Addendum

Additions and Alterations to
Elm Street Elementary School
Phase 2

BID Addendum No.3
to
Drawings and Project Manual

September 3, 2026

BA04B

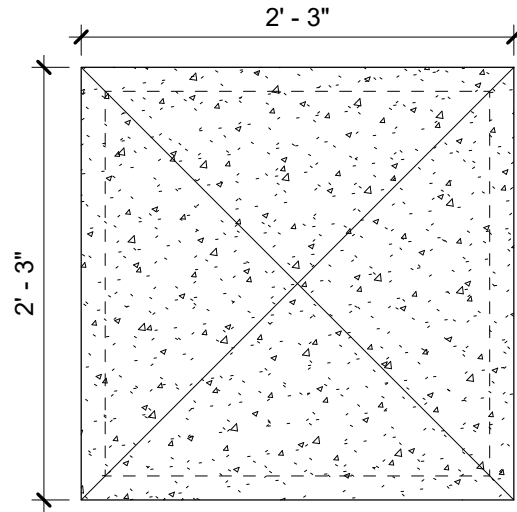
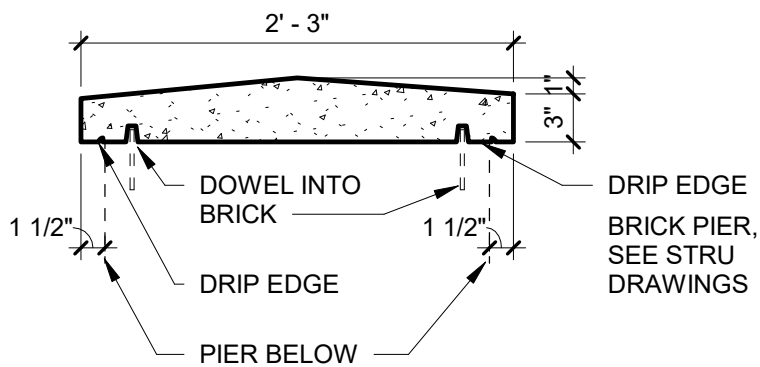
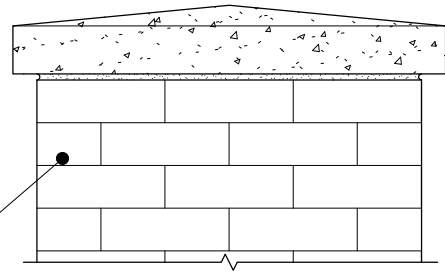
1. ADD Drawing BA04B attached to this addendum.

Please provide a detail for the Column Enclosure associated with Alternate 2 added in Addendum 2

BA05B

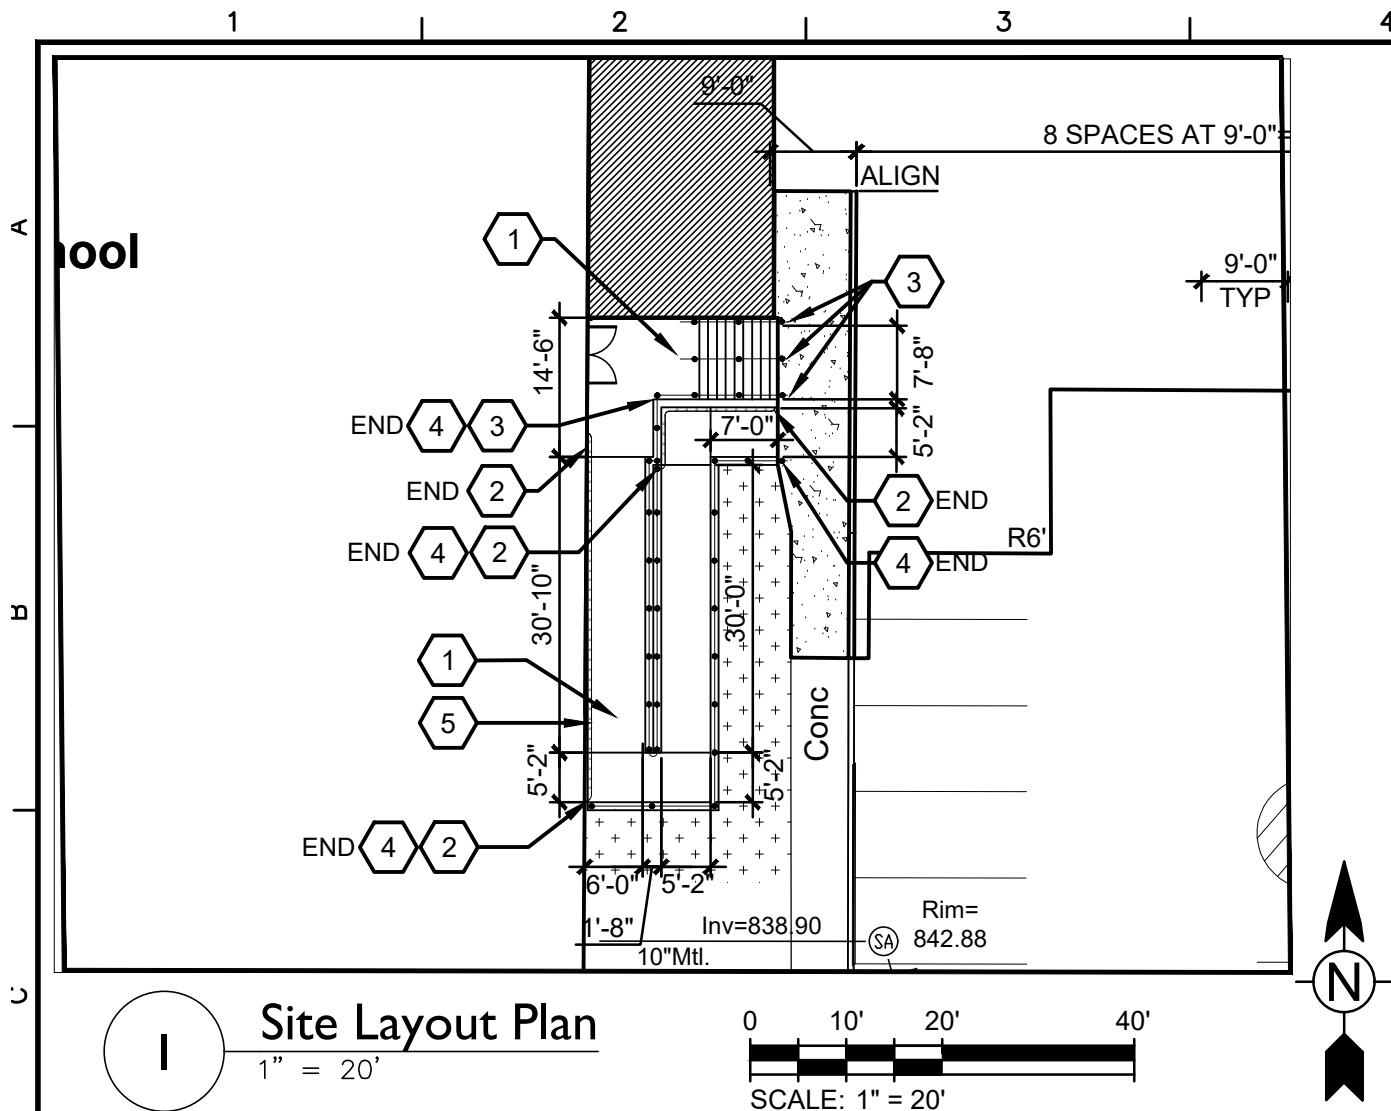
1. Detail 12, ADD as shown on Drawing BA05B attached to this addendum.

BS04B

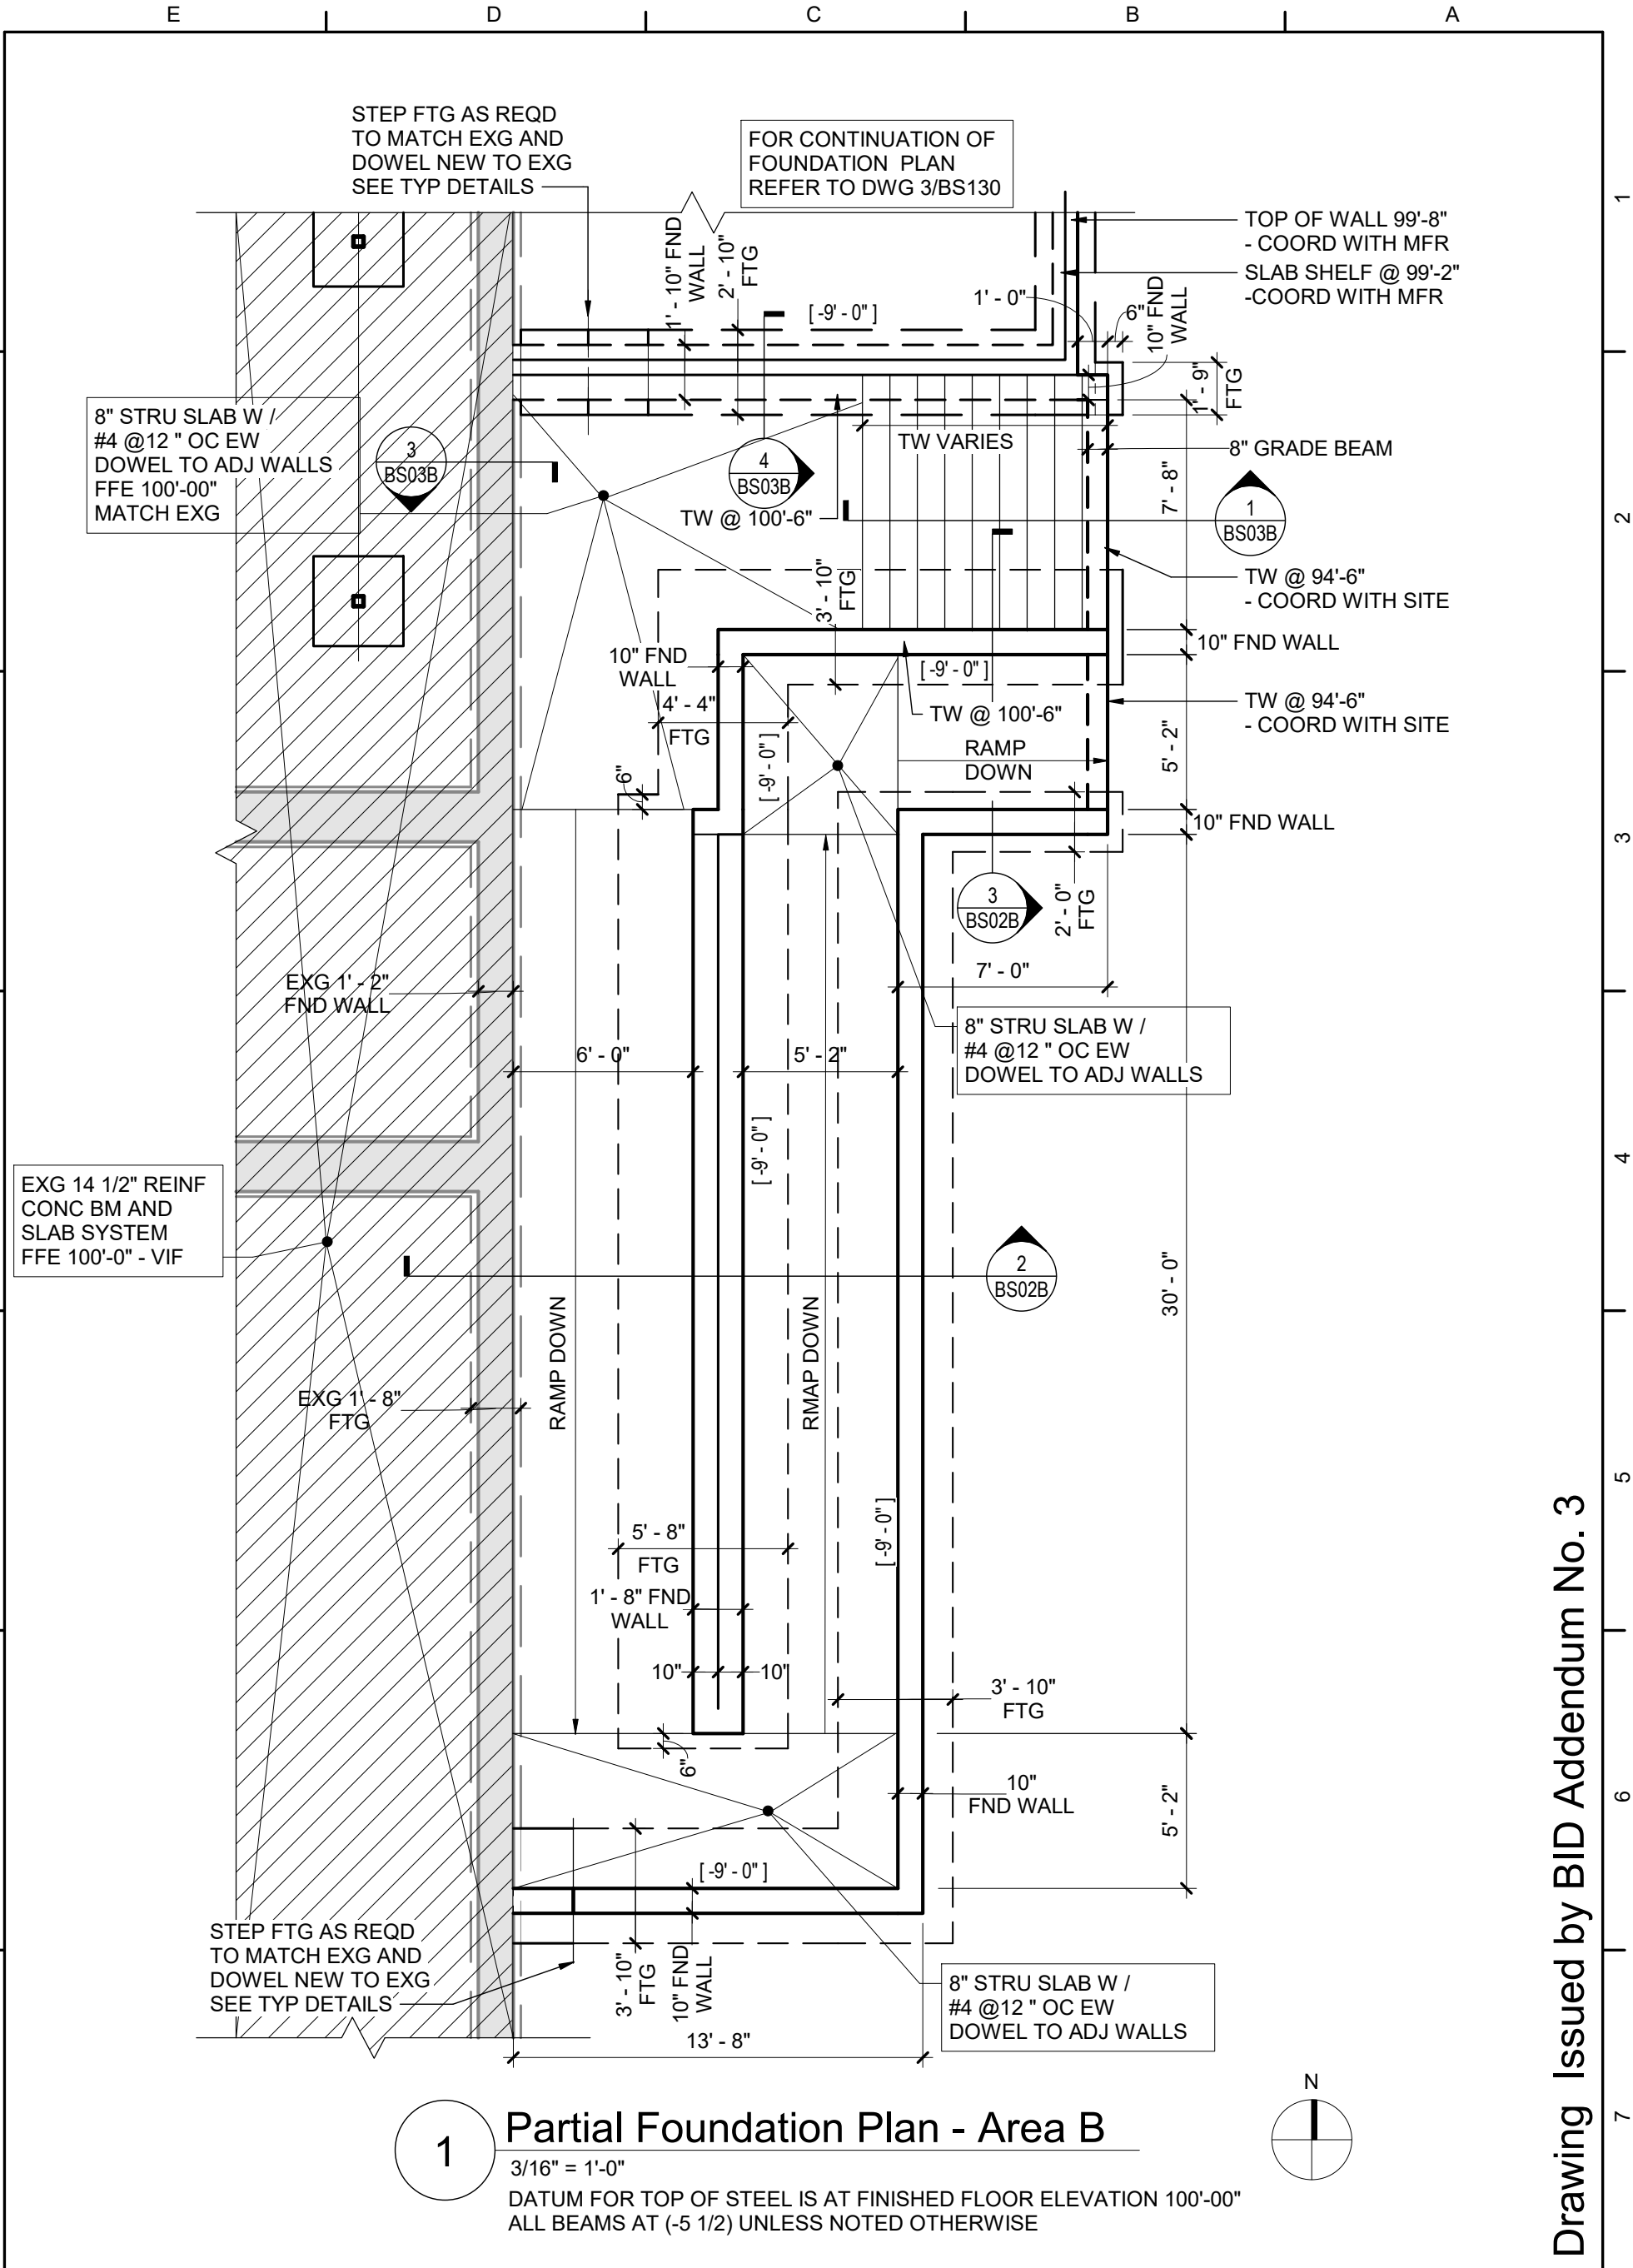
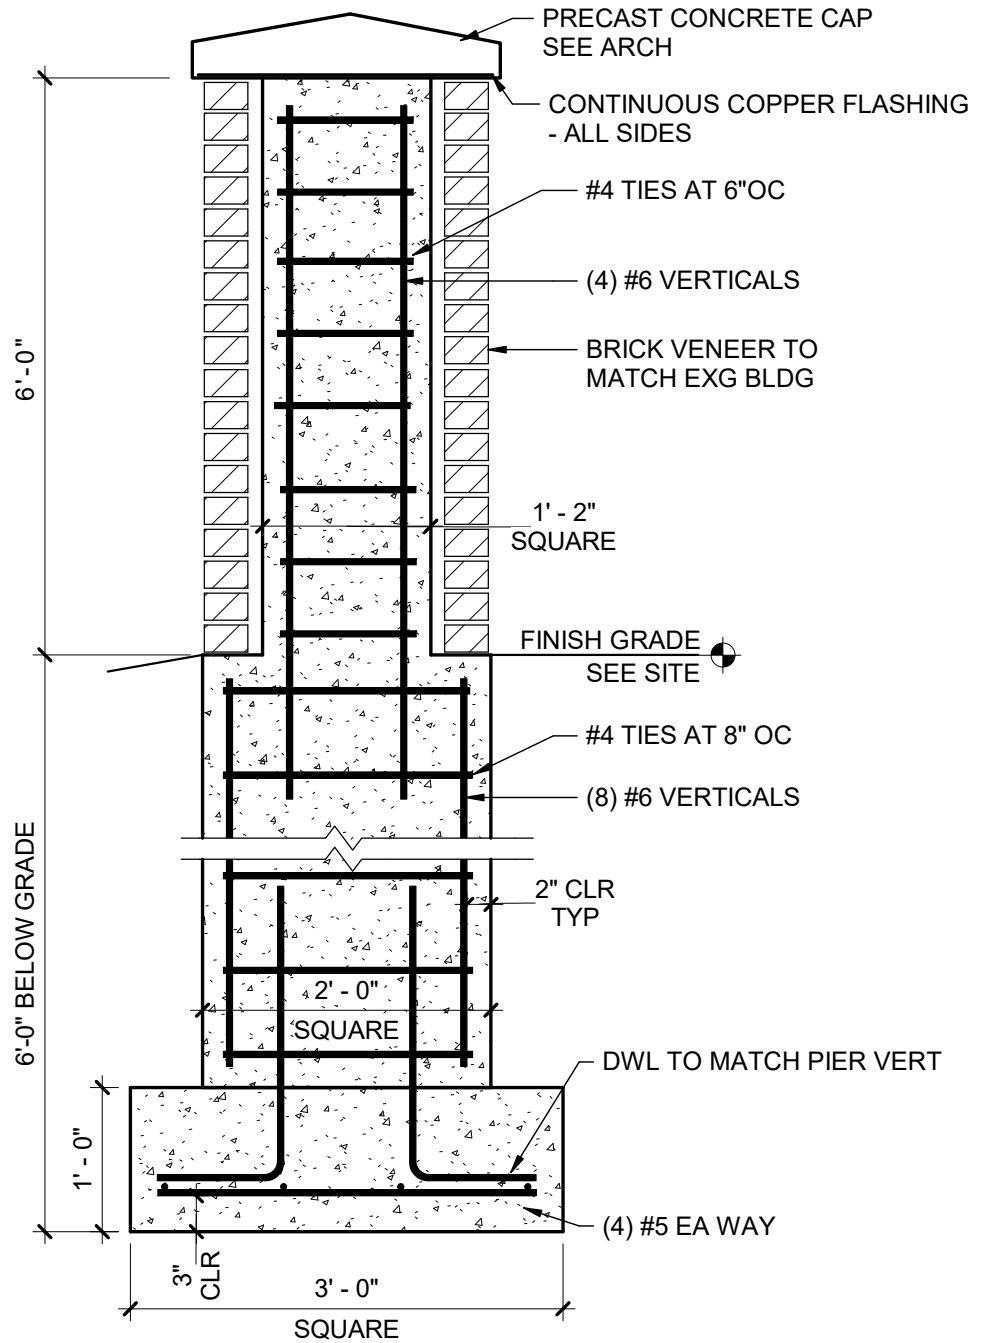
1. ADD Drawing BS04B Sign Pier Detail attached to this addendum
2. ADD Drawing BS01B Ramp Foundation Plan attached to this addendum
3. ADD Drawing BS02B Foundation and Ramp Details attached to this addendum
4. ADD Drawing BS03B Ramp Details attached to this addendum

Drawn by:	Date:	Drawing No.:
SAS	02/23/2026	BE02B

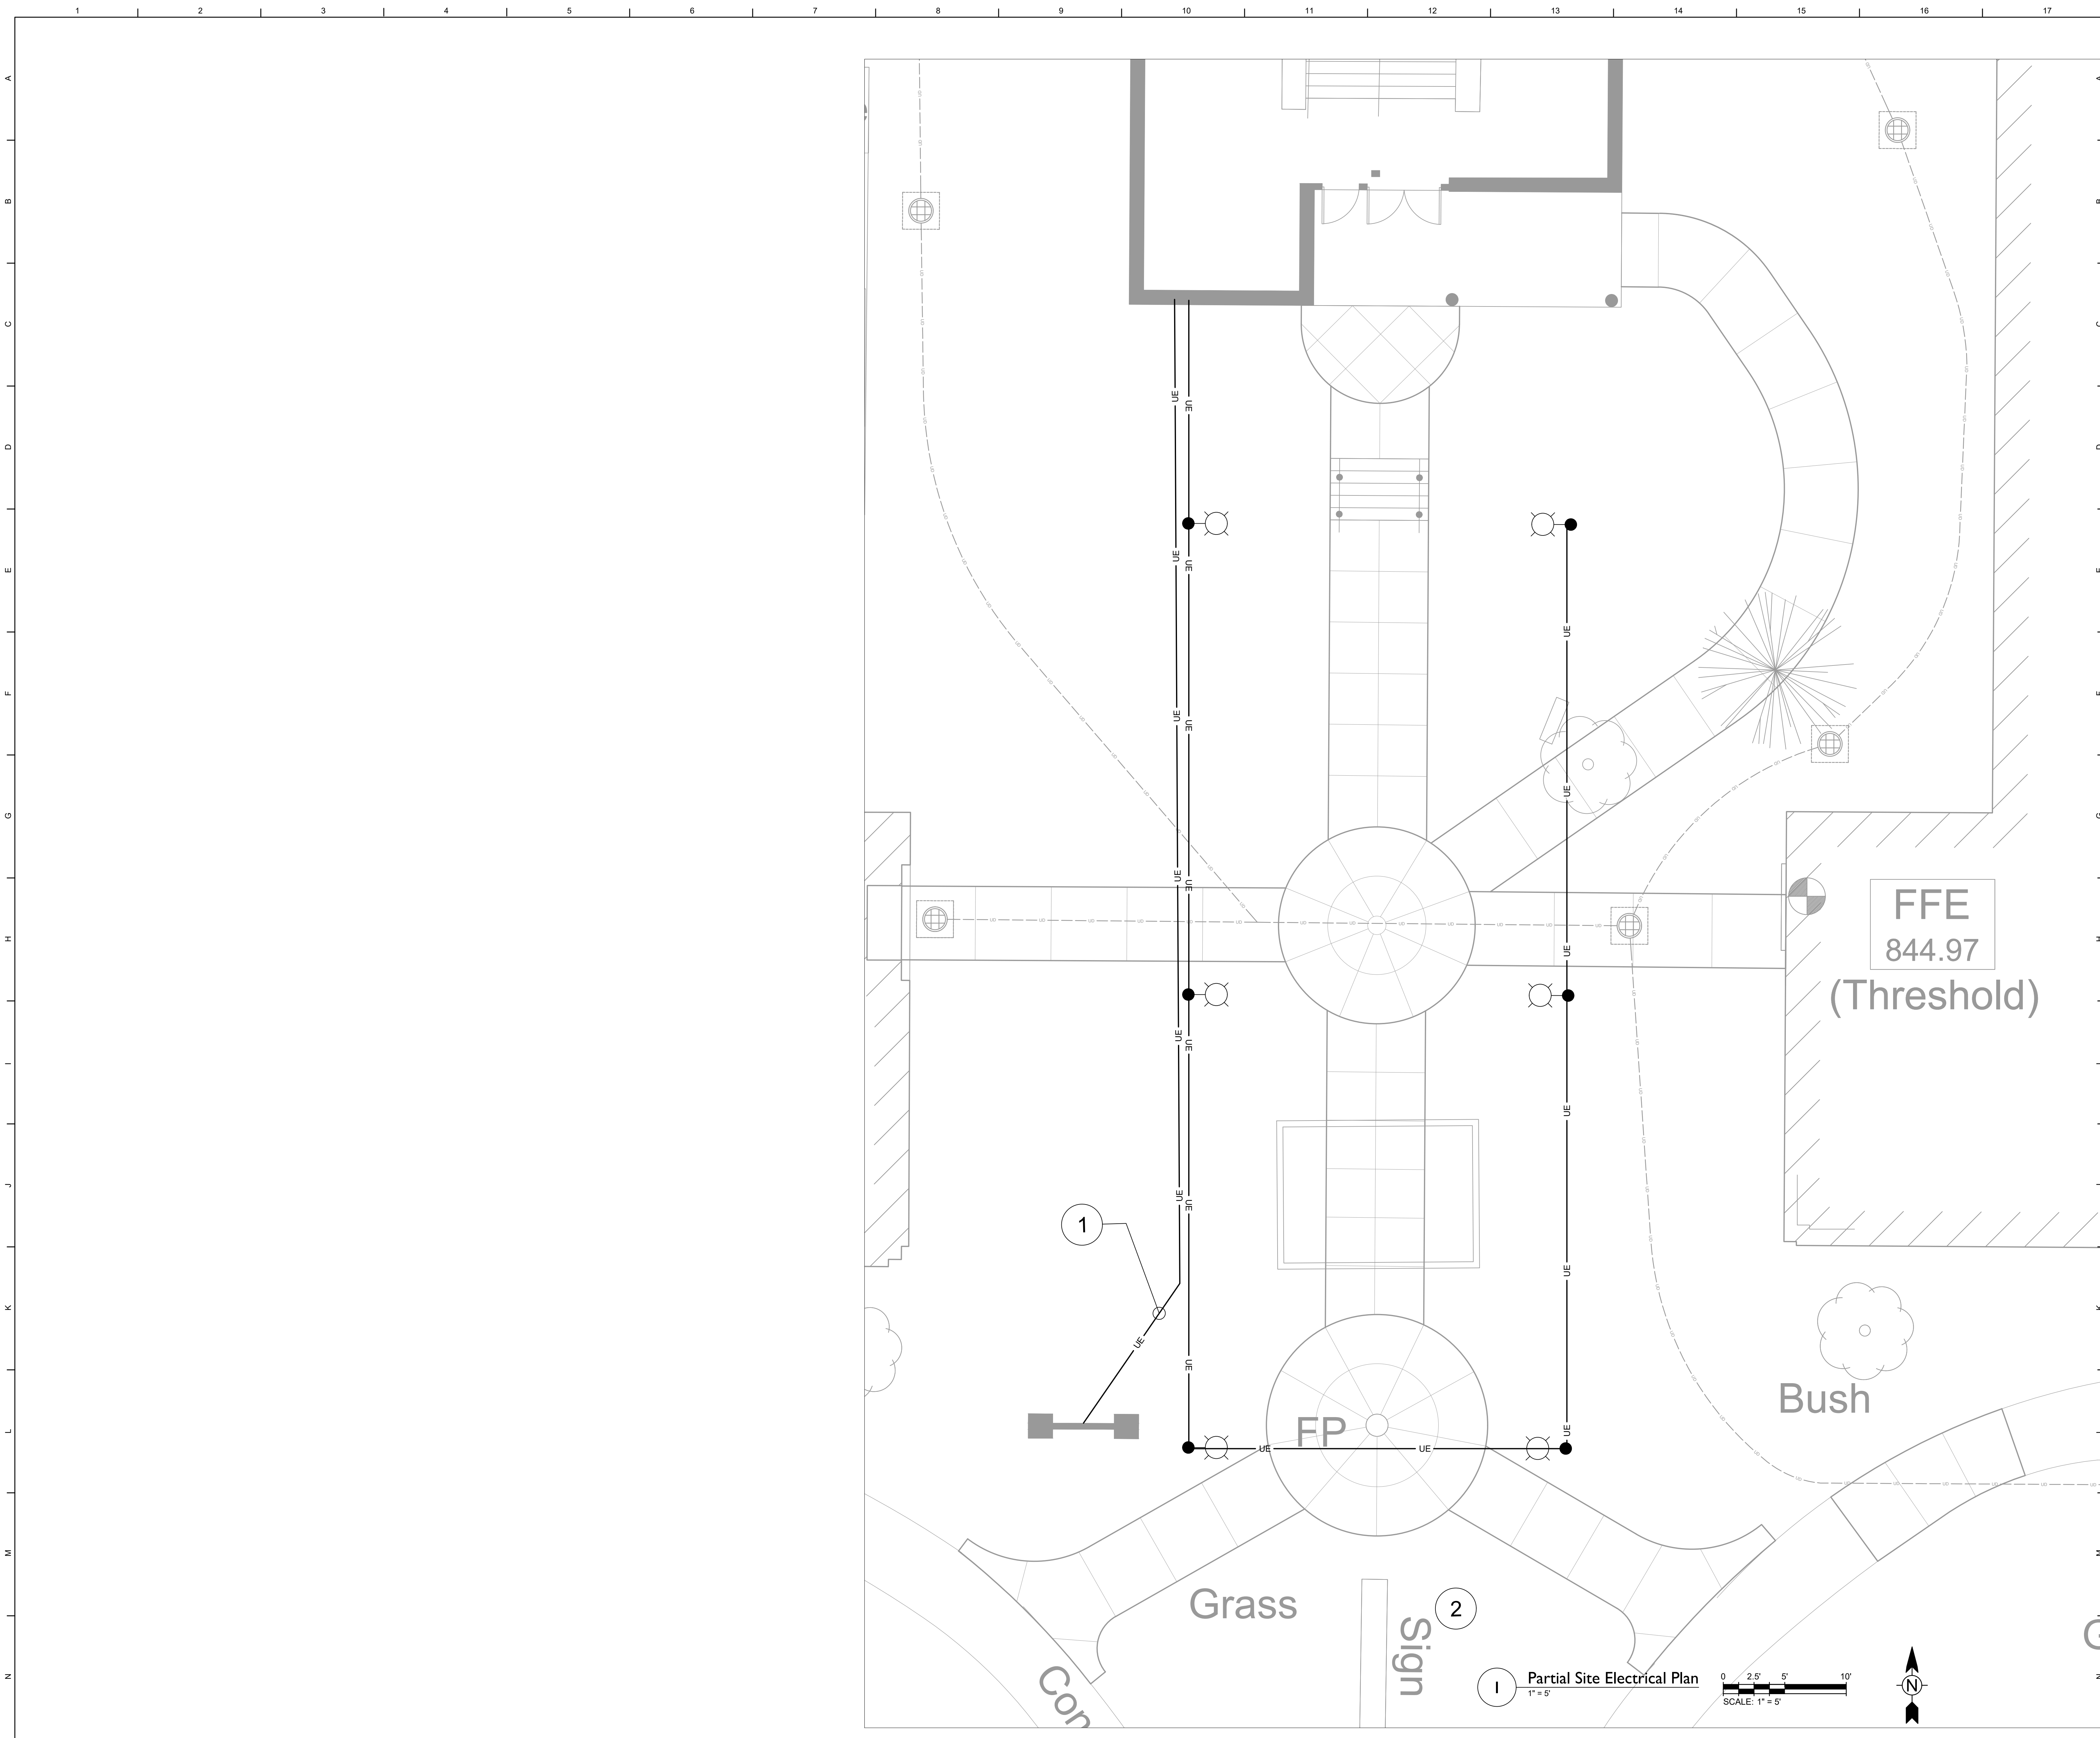
“BE02B Partial Site Electrical Plan”

- 1 PROVIDE ELECTRICAL CONNECTION TO SIGN. CONNECT TO SPARE 20A-1P BREAKER IN PANEL LP2 IN CORR 100.1 WITH (2)#10, (1)#10G IN 3/4" C.
- 2 REMOVE POWER CIRCUITRY TO EXISTING SIGN BACK TO SOURCE. ABANDON CONDUIT IN PLACE. LABEL ANY UN-USED CIRCUIT BREAKERS AS "SPARE"
